PUD Amendment – Monument Sign Application

Site: 27777 Southfield Road
Applicant: Allen Industries
Plan Date: January 9, 2024
Zoning: PUD – Village Center District
Parcel ID: 24-14-432-006
Proposal: Restaurant Monument Sign

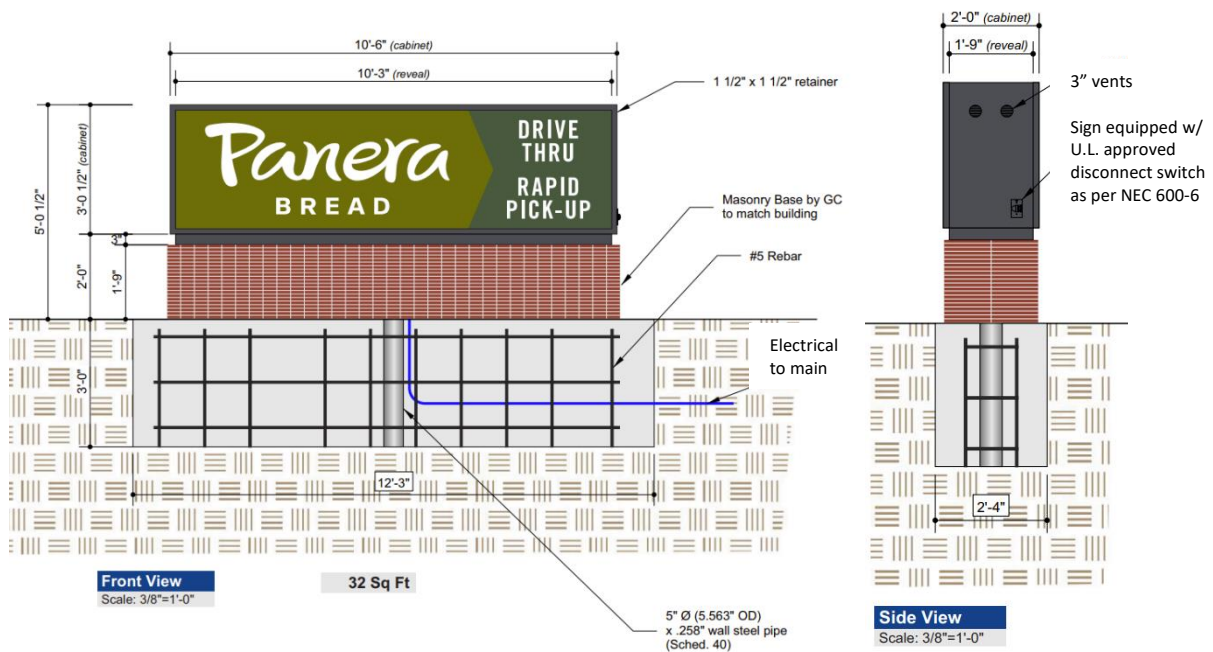
1. **The sign structure encroaches the clear vision zone and exceeds the 30" height limit allowed within the zone. See the diagram at the end of this review letter.**
2. Section 52-24.D. allows for a maximum sign area of 20 square feet per side. Therefore, the total area, including the sign and all supporting structure components for the monument sign shall be limited to no more than 60 square feet (three times the size of the sign surface display area of the sign). **The sign area for each side is 30.75 square feet. When multiplied by 3, the total sign and supporting structure amounts to 92.25 square feet for each side, which exceeds the 60 square foot limit by 32.25 square feet.**
- 3.
